TRANS/WP.29/GRE/2003/27
4 July 2003

PROPOSAL FOR A DRAFT SUPPLEMENT 24 TO
THE 03 SERIES OF AMENDMENTS TO REGULATION No. 37

(Filament lamps)

Transmitted by the expert from the International Electrotechnical Commission (IEC)

The drawing of filament shape No. 3, correct to read (replace by new drawing):

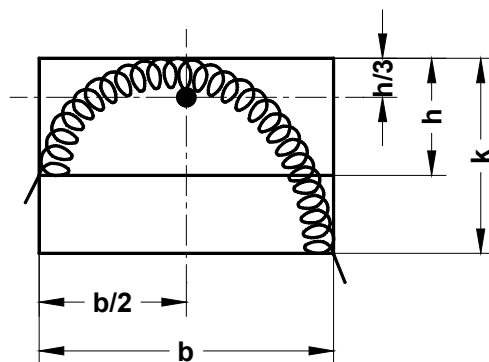
- Paragraph 3.9.4: New sentence should start with capital "t".
- Sheet W21/5W/1 the reference to the cap sheet, in the number "--" was missing.
- Sheet WY5W/1: was integrated into sheet W5W/1.
- Sheet WY21W/1: colour of bulb changed by colour of light;
- Annex 4: drawing of filament shape #3 is not complying the indicated requirements to the dimensions: $b \leq 3h$ and $k < 2h$. Although drawing is only to indicate the essential dimensions, it appeared misleading in laboratory practice;

Add at the end of the text, to read:

" intersection of the dash-dot lines.

The drawings are intended only to demonstrate the essential dimensions."

CATEGORIES H8 AND H8B

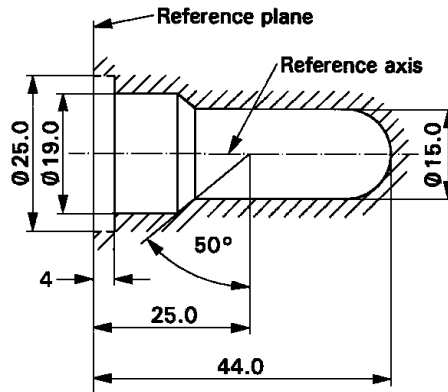
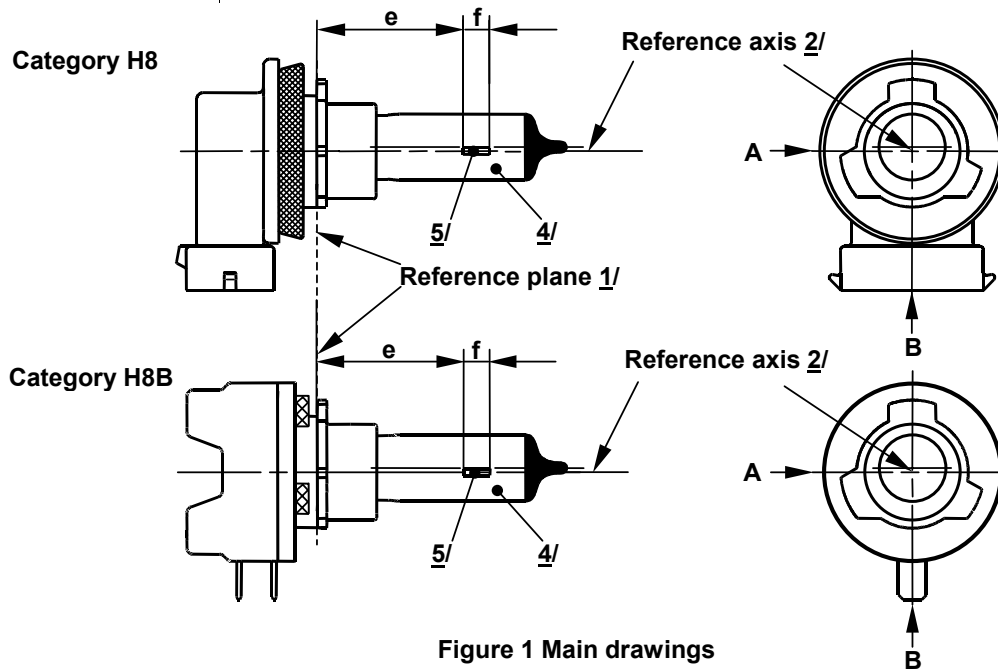
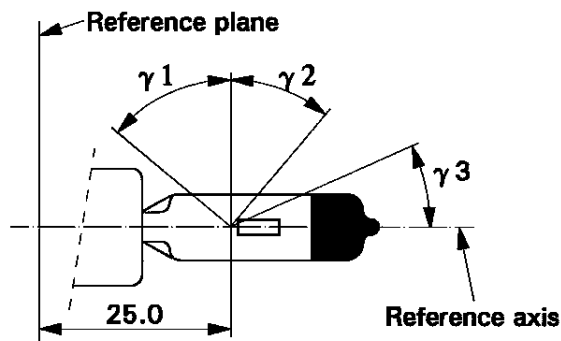
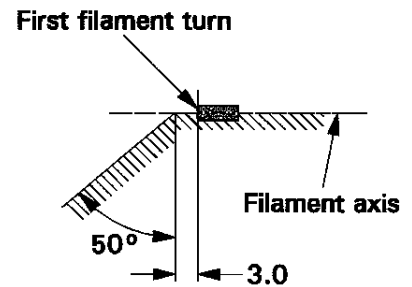
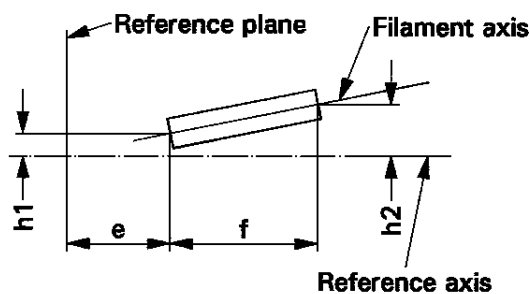
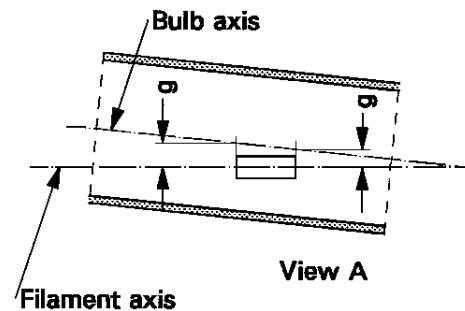
Sheets H8/1 to 4, replace by new sheets H8/1 to 4; (see next pages).

The evaluation of the suitability of (existing) light sources for Adaptive Frontlighting Systems (AFS) was assigned the specific Task Force of Working Party "Brussels 1952" (GTB WG Light Sources). A first outcome was a proposal for a so-called "one-touch" base design of H8, H9 and H11. "One-touch" means mechanical and electrical fixation at the same time. The length of the cap is as short as possible. The proposal was relayed to IEC because it did concern an additional version of the cap while the characteristics of the light source were not changed. Proposed designations are H8B, H9B and H11B.

Figure 1 - Main drawings

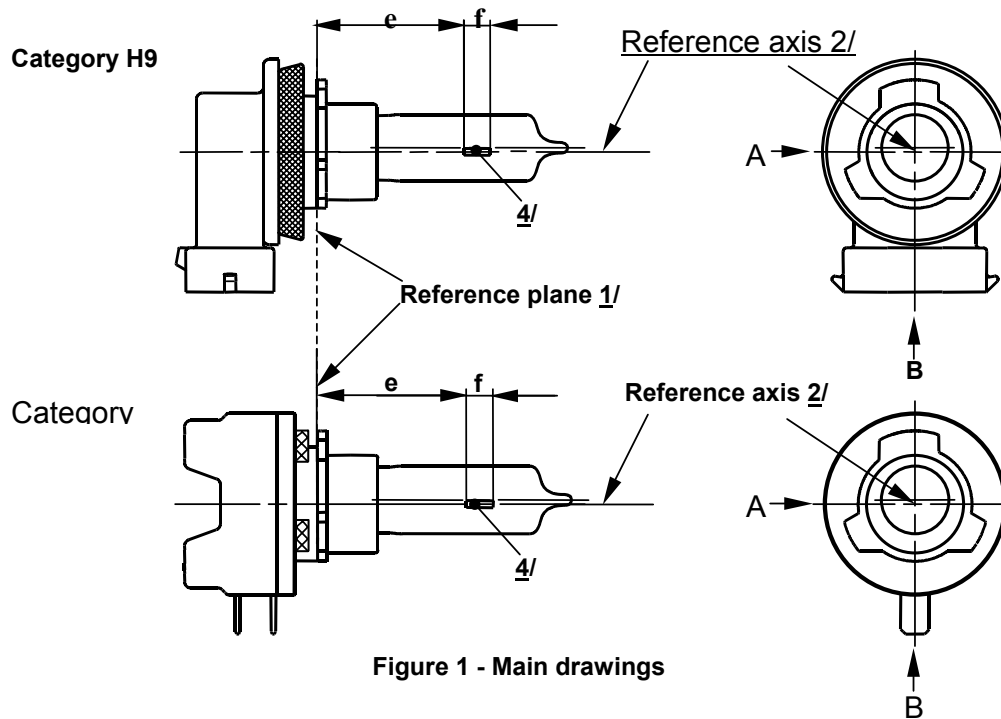
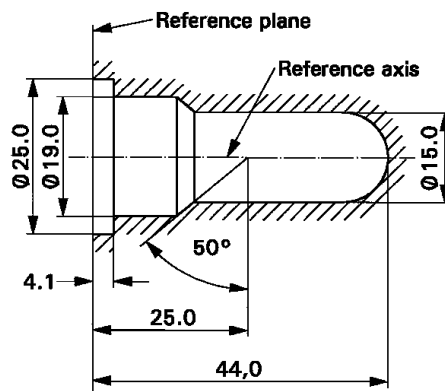
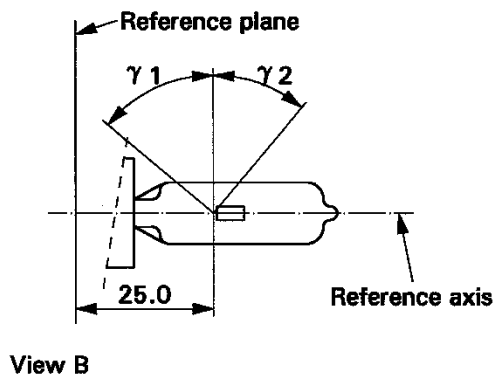
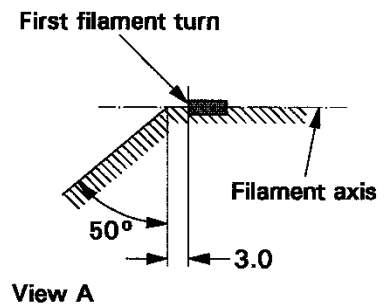
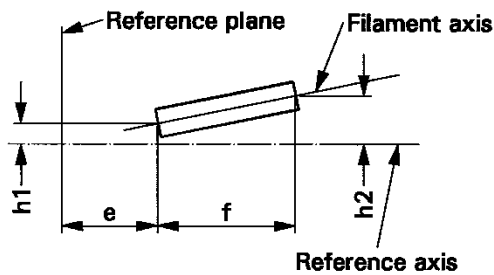
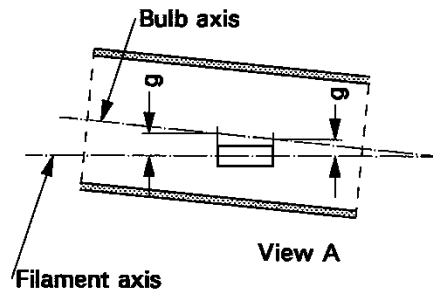
Sheets H9/1 to 4, replace by new sheets H9/1 to 4; (see next pages).

Sheet H11/1

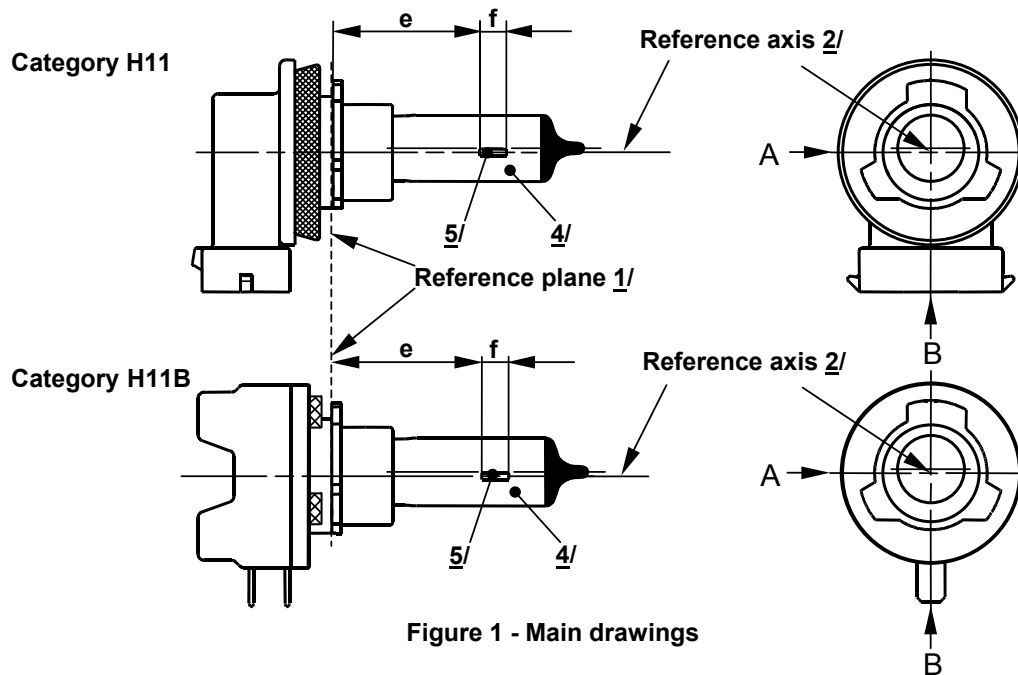
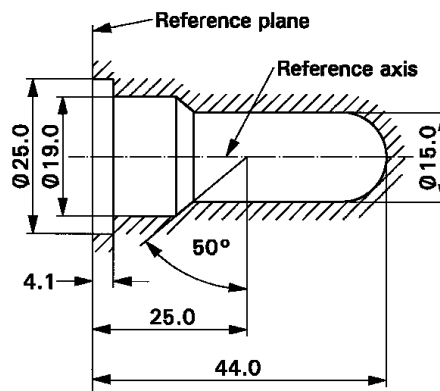
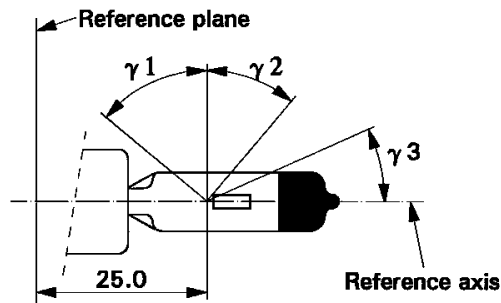
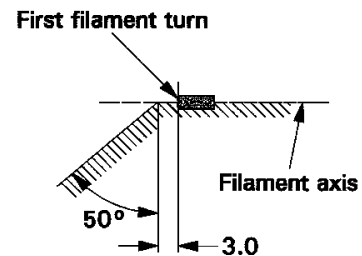
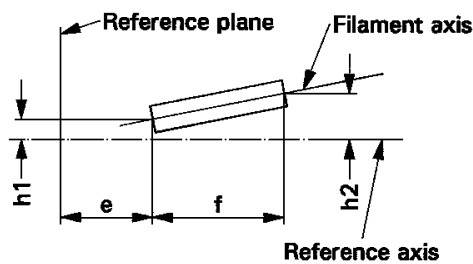
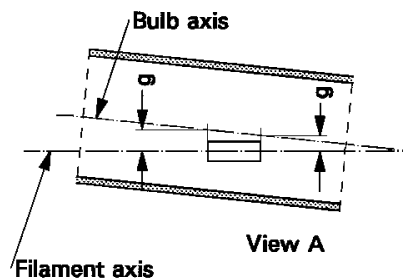
Sheets H11/1 to 4, replace by new sheets H11/1 to 4; (see next pages).
